Responsible: Dieter Rutz
Date: 17.07.2012

Changed fitting for the heating resistor of IWT 1466.0W - spare-part no. 439423

Attention: Wiring colours for the old configuration.

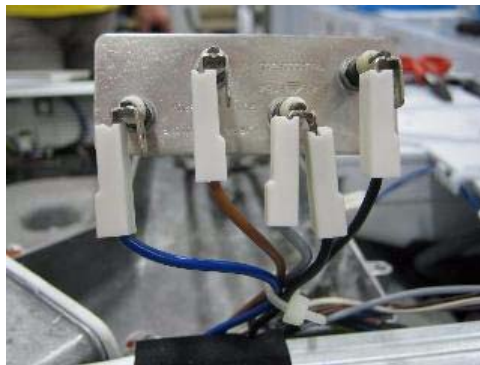
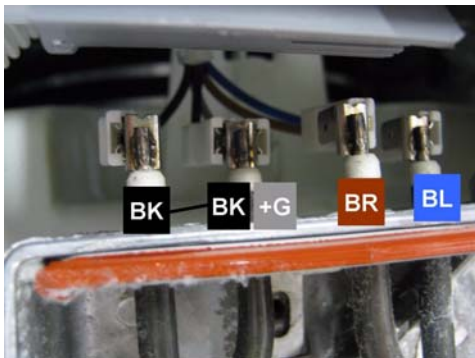
On the basis of an improved production method for the heating element, the fitting of this element has now been changed. The new heating elements are compatible with the heating elements in the older models, but the wiring will need to be changed as follows.

Attention: Wiring colours for the new configuration.

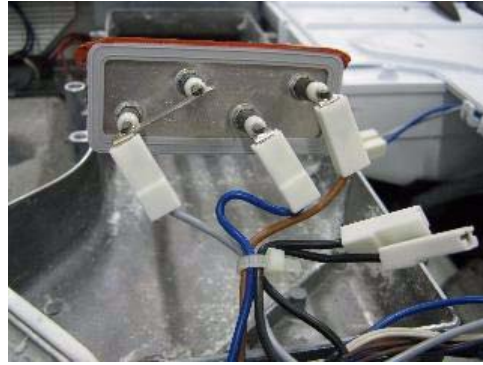
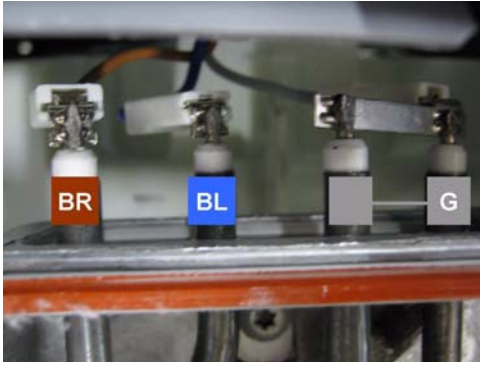
5. Replace the heating element with the new heating element.

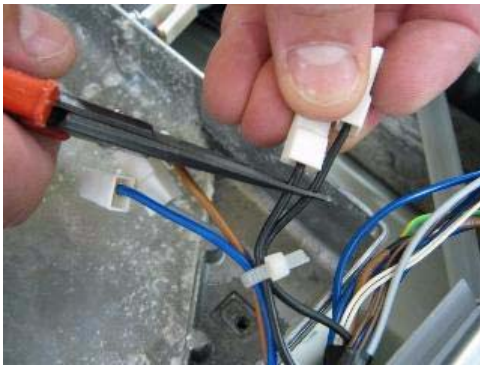
Remove the black "jumper". To do so, first of all cut off the fasten connector.

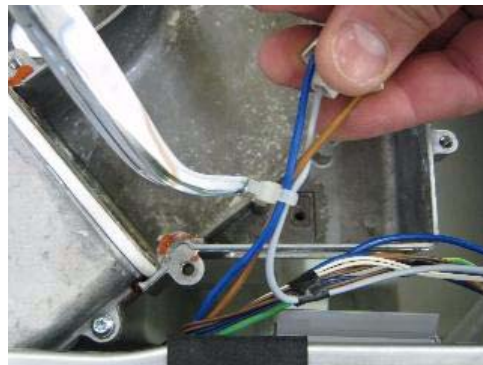
Then remove the cable and tighten the cable clamp.

CAUTION! It is essential to seal the edge of the heating element with a suitable adhesive before installing the element. Replace the cable in the slot.
